## 363 Cocoanut Row, Palm Beach, FL 33480

## REVISED LANDMARKS 04-06-2023

LPC# COA-23-002 (JANUARY 2023)

SINCE THE JANUARY LPC MEETING, THE PROJECT HAS RECEIVED APPROVAL FROM TOWN COUNCIL OF ALL VARIANCES, SITE PLAN APPROVAL & SPECIAL EXCEPTIONS

\* AC-4.2.1

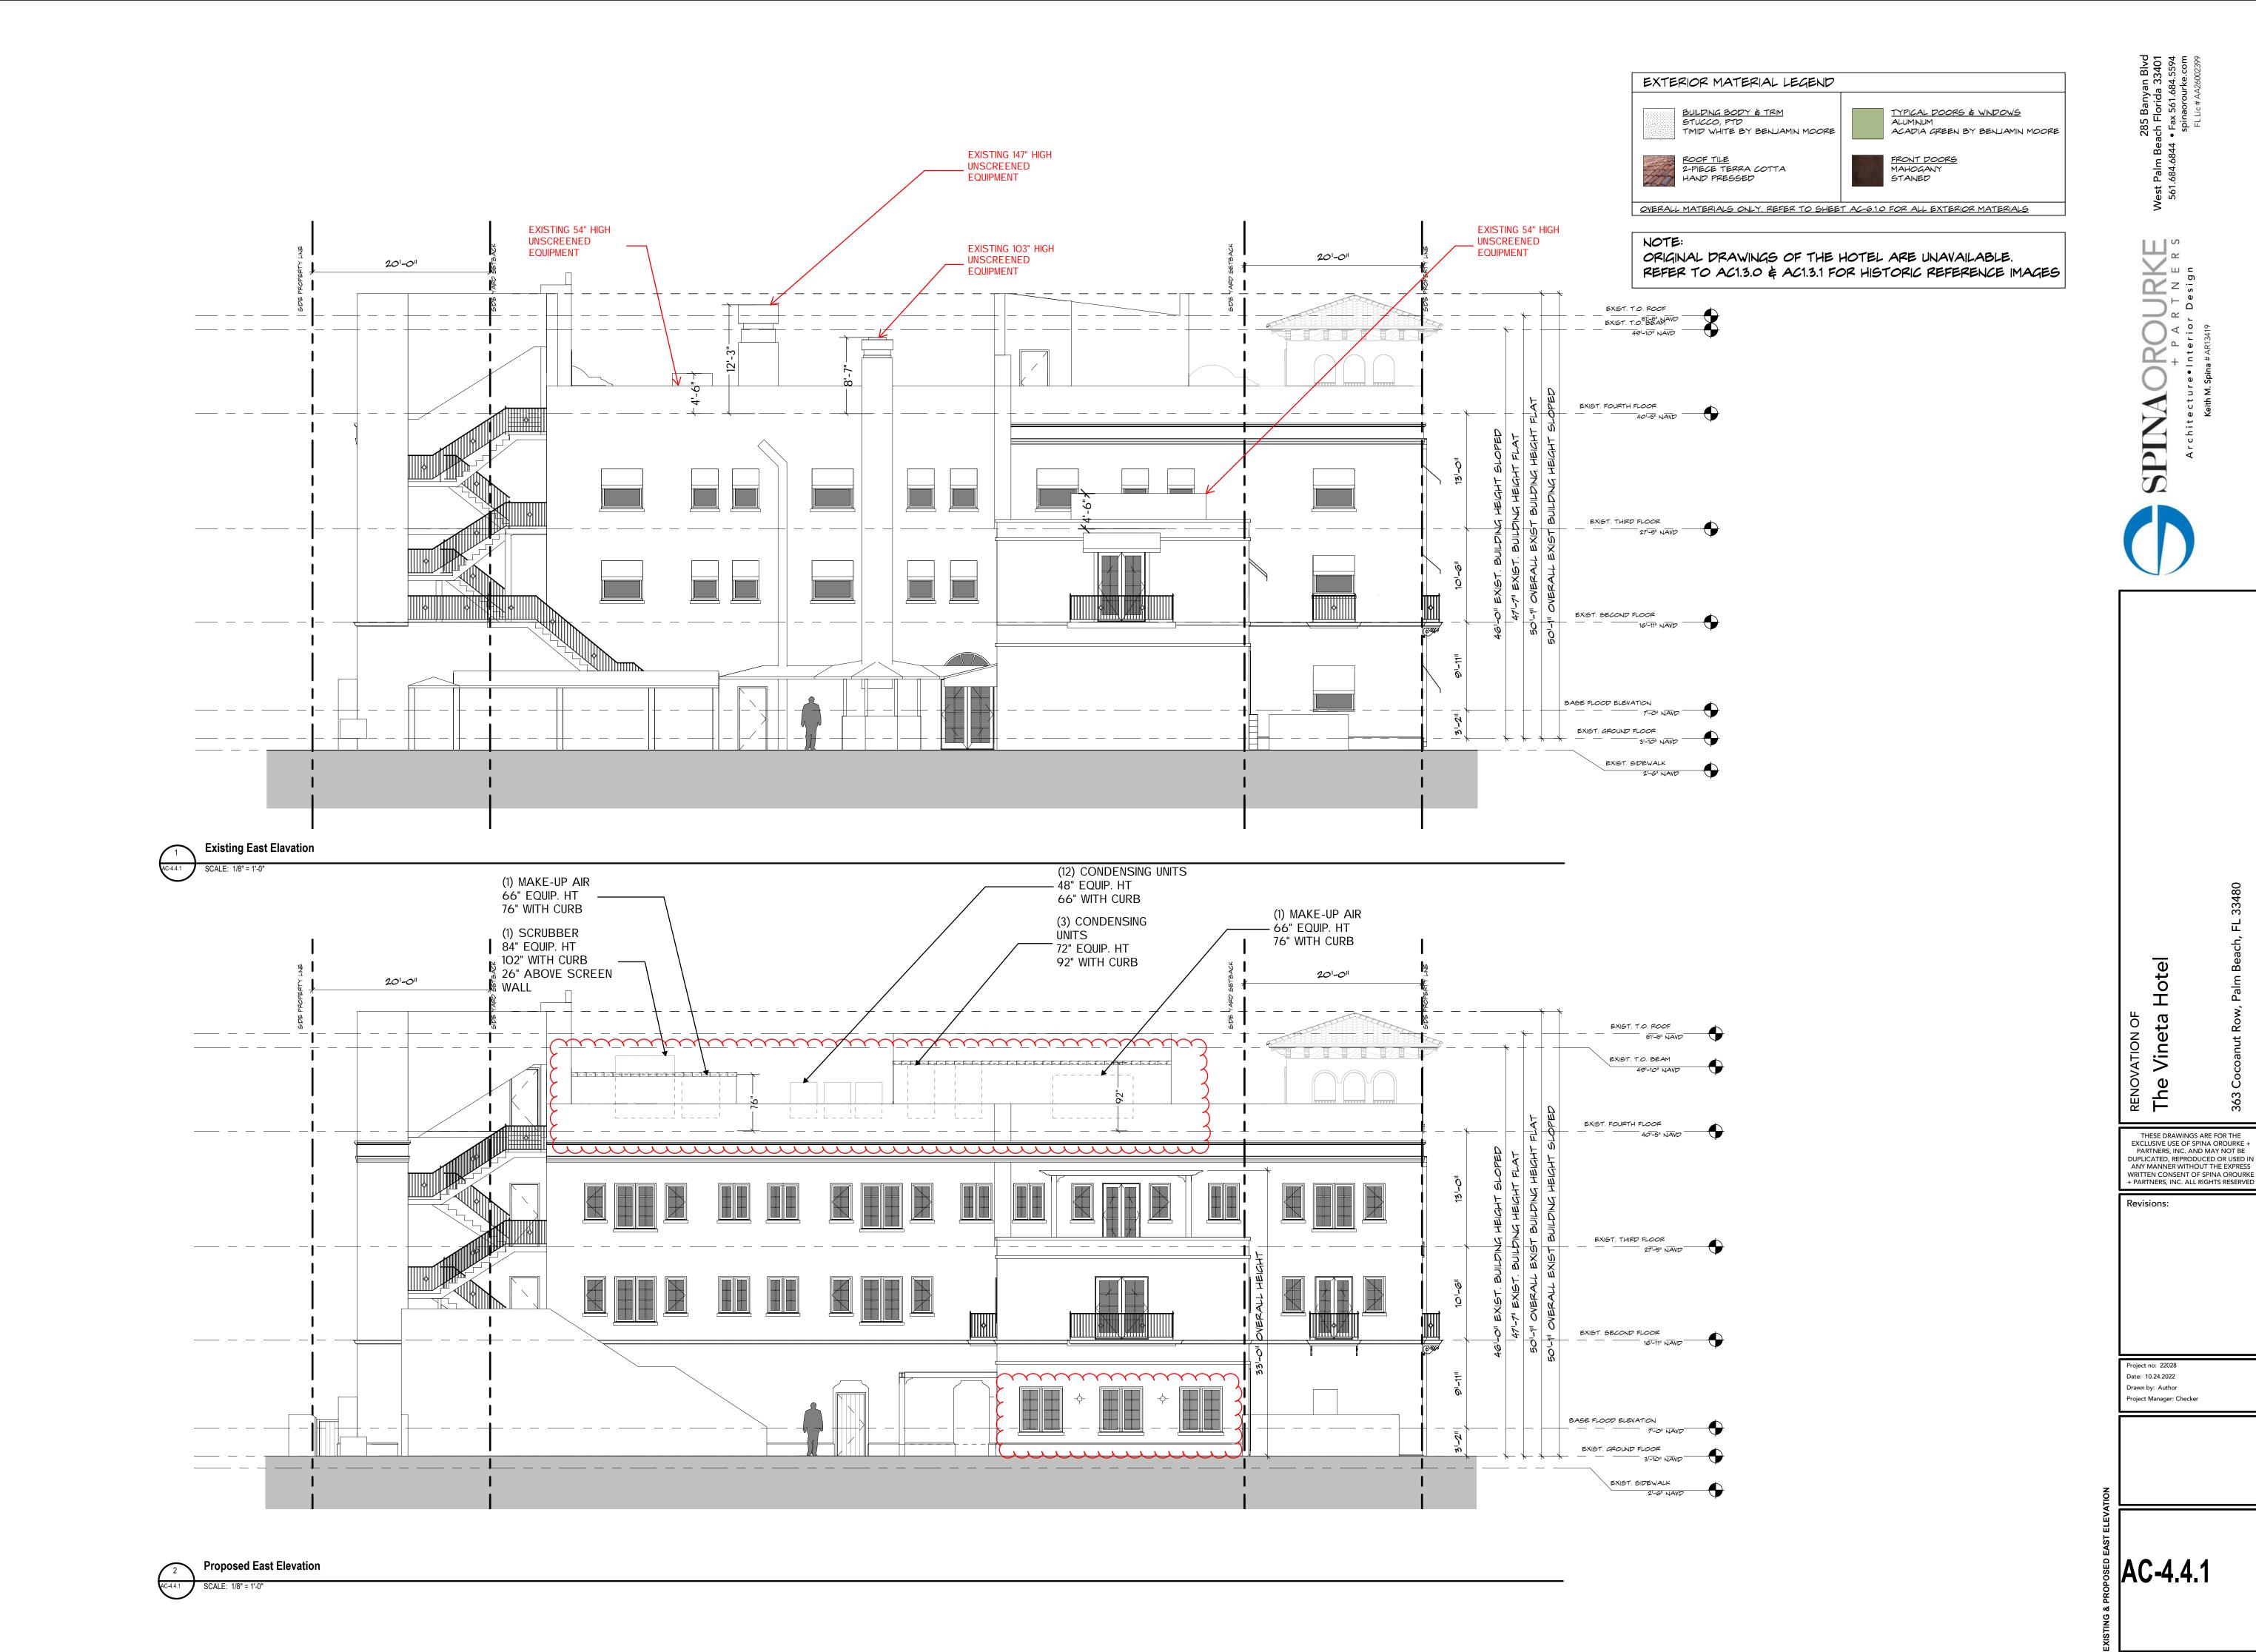
POOL LOUNGE FENESTRATION

PREVIOUSLY APPROVED FLOOR PLAN - NANAWALL

PREVIOUSLY APPROVED SOUTH ELEVATION - NANAWALL

PREVIOUSLY APPROVED EAST ELEVATION - SINGLE WINDOWS

PROPOSED FLOOR PLAN - (5) FRENCH DOORS

PROPOSED SOUTH ELEVATION - (5) FRENCH DOORS

PROPOSED EAST ELEVATION - DOUBLE WINDOWS
